UNITED STATES PATENT AND TRADEMARK OFFICE

APPLICATION NO.	FILING DATE	FIRST NAMED INVENTOR	ATTORNEY DOCKET NO.	CONFIRMATION NO.
09/943,262	08/30/2001	Tohru Ishitani	1743/193	8263

Office Action Summary

DETAILED ACTION***Drawings***

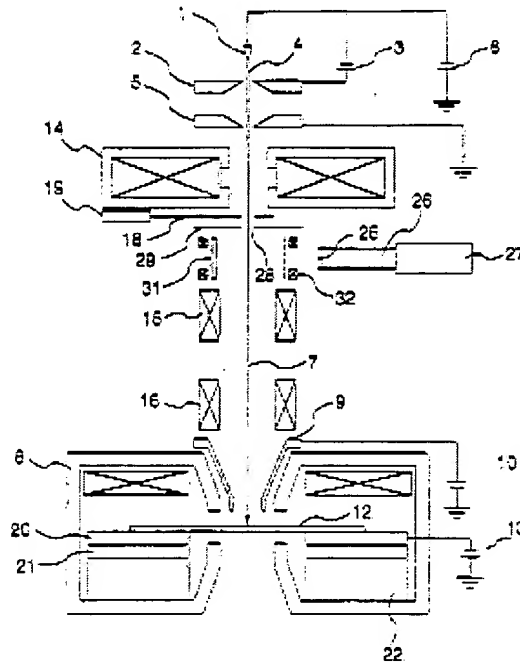
Todokoro et al. disclose a scanning charged-particle microscope having:

a charged-particle source (FIG. 4, element 1),

a lens for focusing the charged-particle optical beam emitted from said charged-particle source (FIG. 4, element 14), and

a scanning deflector for scanning said charged-particle optical beam in two-dimensional form on a sample (FIG. 4, elements 15-16),

a passage aperture for limiting the passage of the charged-particle optical beam is located between the charged-particle source and said scanning deflector (FIG. 4, elements, 28-29).

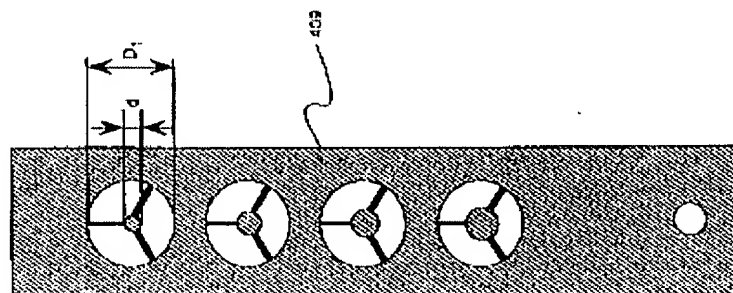
Todokoro et al. does not disclose that the passage aperture formed in a plate-like body movable with respect to said charged-particle optical beam (**Referring to claims 3, 9**) includes a member for limiting the passage of the charged-particle optical beam provided at least in the center of said passage aperture, the plate-like body also includes a circular aperture (**Referring to claims 4, 8**), and wherein the scanning charged-particle microscope is characterized in that said circular aperture and said annular aperture are formed in a first plate-like body and a second plate-like body, respectively, in that said first plate-like body is provided with a charged-particle optical beam cutoff portion in addition to the circular aperture and said second plate-like body is provided with a circular aperture in addition to the annular aperture, and in that both the first plate-like

body and the second plate-like body are provided with a movement feature (**Referring to claims 10, 11**).

However, Kakibayashi et al. disclose a passage aperture formed in a plate-like body movable with respect to said charged-particle optical beam (FIG. 21: the element 409 is movable respectably to the charged-particle optical beam for selecting an appropriate aperture) having a member for limiting the passage of the charged-particle optical beam provided at least in the center of said passage aperture (FIG. 20-22, element 409), the plate-like body also includes a circular aperture (FIG. 21: the aperture without a limiting element), and wherein the scanning charged-particle microscope is characterized in that said circular aperture and said annular aperture are formed in a first plate-like body and a second plate-like body, respectively, in that said first plate-like body is provided with a charged-particle optical beam cutoff portion in addition to the circular aperture and said second plate-like body is provided with a circular aperture in addition to the annular aperture, and in that both the first plate-like body and the second plate-like body are provided with a movement feature (FIG. 20, elements 409, 410).
